ADMINISTRATION REPORT **REZONING** DOWNTOWN

10123 - 106 Street NW

To allow for a high rise, high density, mixed use tower

Recommendation: That Charter Bylaw 19785 to amend the Zoning Bylaw from (UW) Urban Warehouse Zone to a (DC2) Site Specific Development Control Provision and replace maps in Section 910 be **APPROVED**.

SITE PLAN SHOWING MINIMUM TOWER SETBACKS

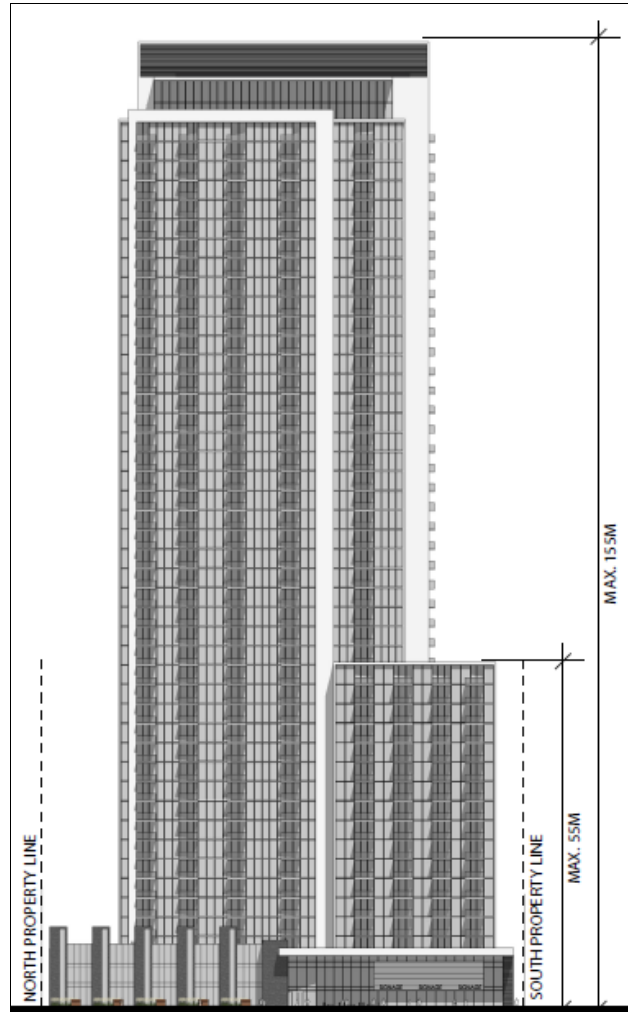
In addition to providing space at ground level, the tower is also appropriately stepped back above the podium with the tower having a 9.0 m west setback. In front of the commercial uses at ground level, where the setback at ground level is smaller, this will enhance the effect of the tower and alleviate the feeling that it is looming above pedestrians. The tower setbacks in

other directions are also generous relative to their adjacent context. The image below shows the site plan proposed with the DC2 Provision with the on-site space around the tower (tower setbacks) highlighted in red.

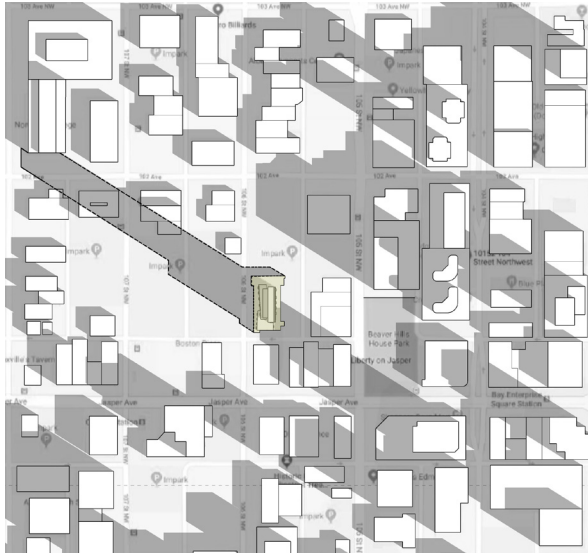
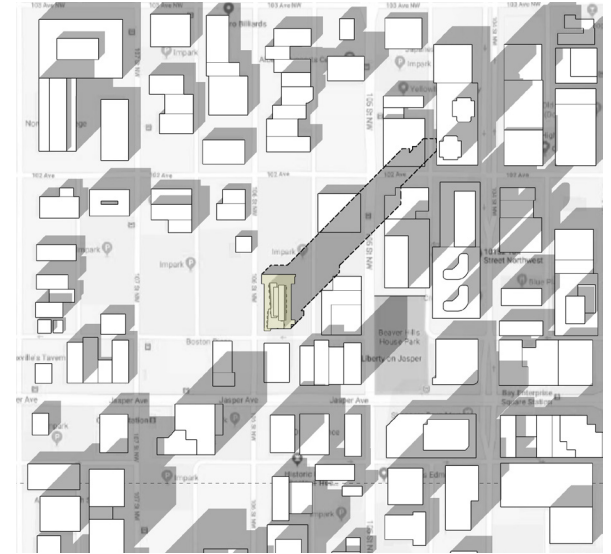
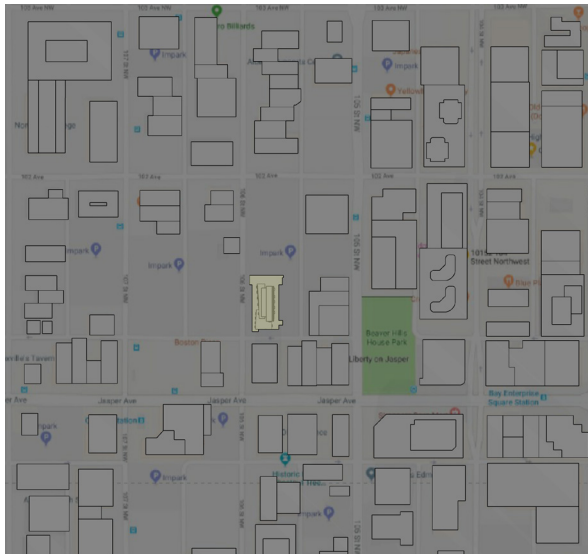
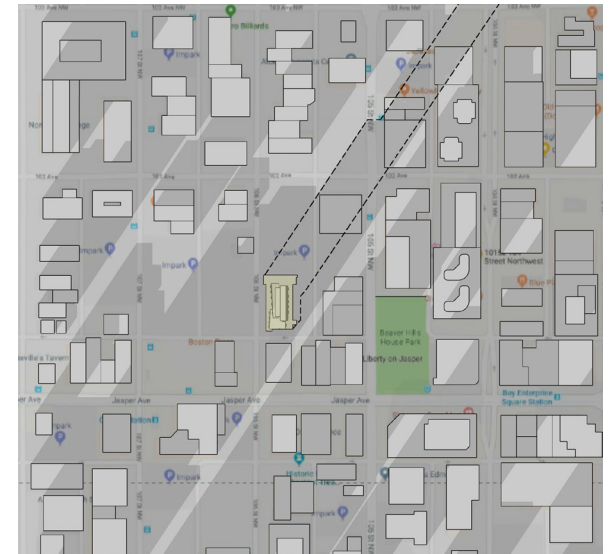
Shadows from this proposed tower will generally be cast to the north most of the day, including over The Shift towers site and sometimes reaching Alex Decoteau Park. The future new Warehouse Park to the west of the site will experience shadow in the morning hours to varying degrees throughout the year. The aforementioned long north-south dimension of the proposed tower subsequently makes a portion of the shadow relatively wide.

Currently, there are no policies or guidelines regarding the maximum amount of shadow a building can cast onto a public park. There are several recently approved rezonings for tall towers around this future park site that will all create some shadow on it at different times of the day and different times of the year, if they all get built. Administration believes these shadows are not overly problematic given that it was always known that this future downtown park site would be among towers. The park is large enough that with these shadows, there will still be many places with sun access, giving people options for what they are seeking in using the park space.
